subject: RAM Development Traffic Review

MEMORANDUM

The Corradino Group, Inc (Corradino) has been requested to complete a traffic review for the RAM Development located in the southeast corner of the Oakland Park Boulevard (SR 816) and NE 6th Avenue intersection in the City of Oakland Park, Florida. The following are our traffic review comments of the June 18, 2020 resubmittal:

TABLE B-2
PM TRAFFIC VOLUME CALCULATIONS
RAM OAKLAND PARK TRAFFIC ANALYSIS

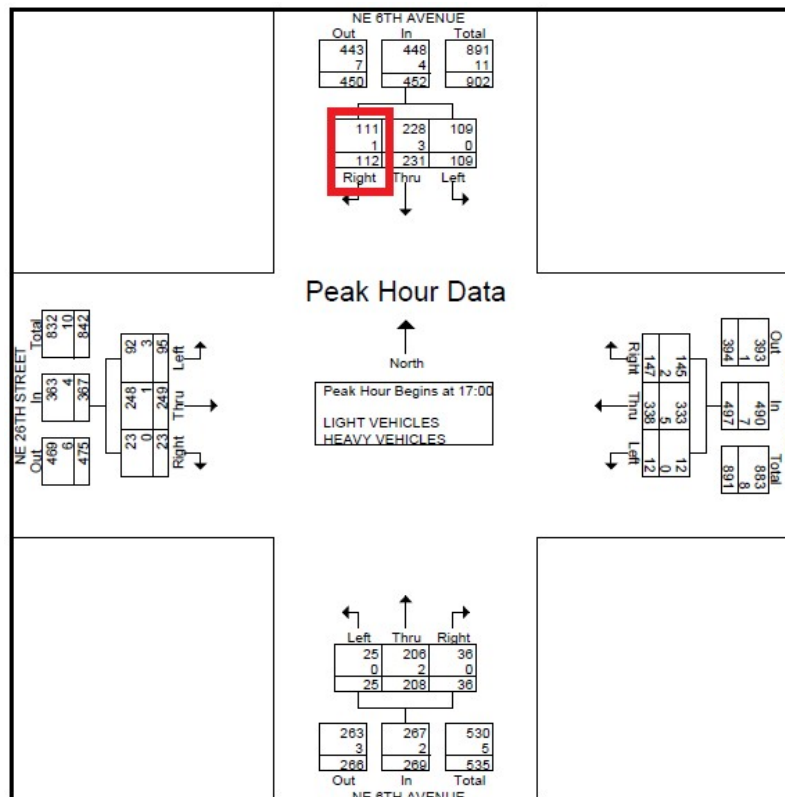
2. Please update the southbound left turn volume at the NE 6th Avenue and NE 26th Street (PM Conditions) in Intersection Volume Worksheet Table B-2. The table has 11 vehicles but the raw traffic counts sheet from Traffic Survey Specialists and Figure 3 indicates 112 vehicles. Please update the traffic analysis if necessary.

TCG 07/01/20 Response: Addressed. The PM peak hour traffic volume in question is the southbound right turn volume at NE 6th Avenue and NE 26th Street (see below). Please update the traffic analysis for all scenarios as necessary.

McMahon Associates, Inc. 06/16/20 Response: We were unable to find any discrepancy in the volumes. The existing southbound left turn volume at the intersection of NE 6th Avenue and NE 26th Street (PM peak hour), in Table B-2 is 112 vehicles, which matches Figure 3. The collected count (by Traffic Survey Specialists) for the southbound left turn lane was 109 vehicles, which was adjusted by a PSCF of 1.03 to calculate the existing peak-season volume of 112 vehicles.

McMahon Associates, Inc. 06/16/20 Response: Please see attached the revised report that corrected the SBLT volume at the NE 6th Avenue/NE 26th Street intersection.

Figure 212.11.1 Clear Sight Triangles

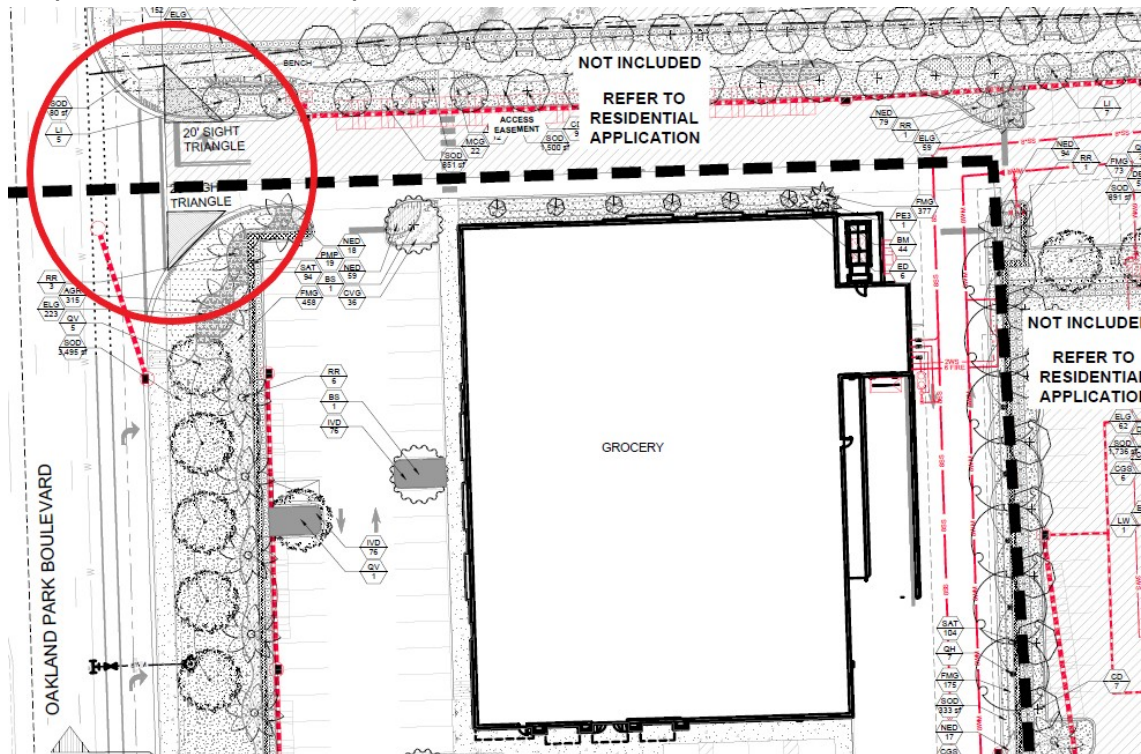
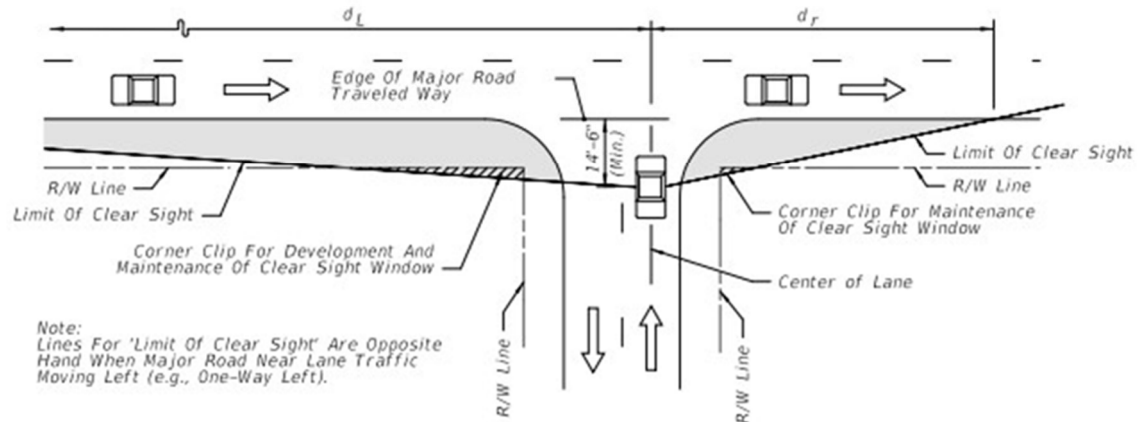
10. Please ensure that the appropriate sight visibility triangles are shown consistently on the site plan, pavement marking and signage plan and the landscape plans. The sight triangles along the Oakland Park Boulevard driveway should meet FDOT criteria as outlined in the FDOT Design Manual (Section 212.11).

TCG 07/01/20 Response: The sight triangles shown at the driveway connection to Oakland Park Boulevard do not meet the FDOT criteria as outlined in the FDOT Design Manual (Section 212.11). Final plan approval will be provided once these plan related items have been addressed.

McMahon Associates, Inc. 06/16/20 Response: Acknowledged.

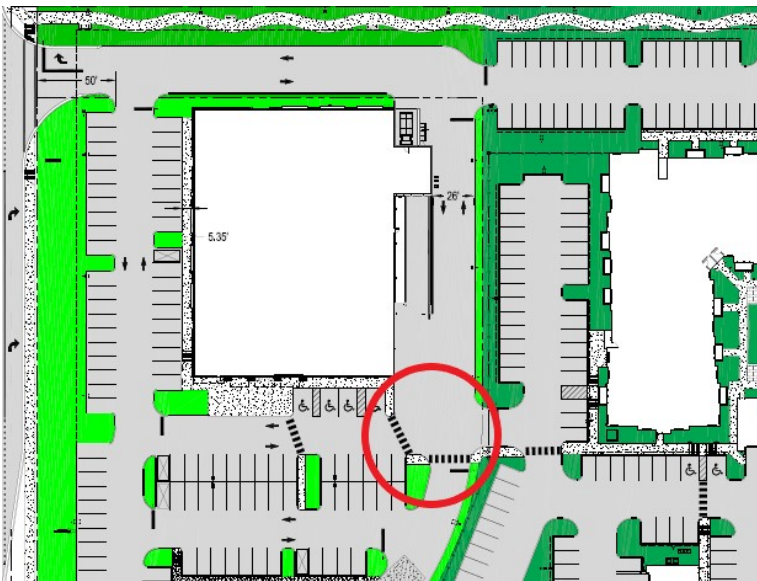
11. Please provide pedestrian crossing signs at the zebra crosswalk markings per MUTCD at the intersections within the RAM development site.

TCG 07/01/20 Response: Please update plan sheet C-1 for the residential and commercial parcels to include callouts for all the proposed signage for both the residential and commercial parcels. Appropriate signage types should be called out per the MUTCD signage type, etc. Final plan approval will be provided once these plan related items have been addressed.

McMahon Associates, Inc. 06/16/20 Response: Please see revised Preliminary Site Plan (Sheet C1 for Commercial) provided under separate cover. Pedestrian crossing signs have been provided.
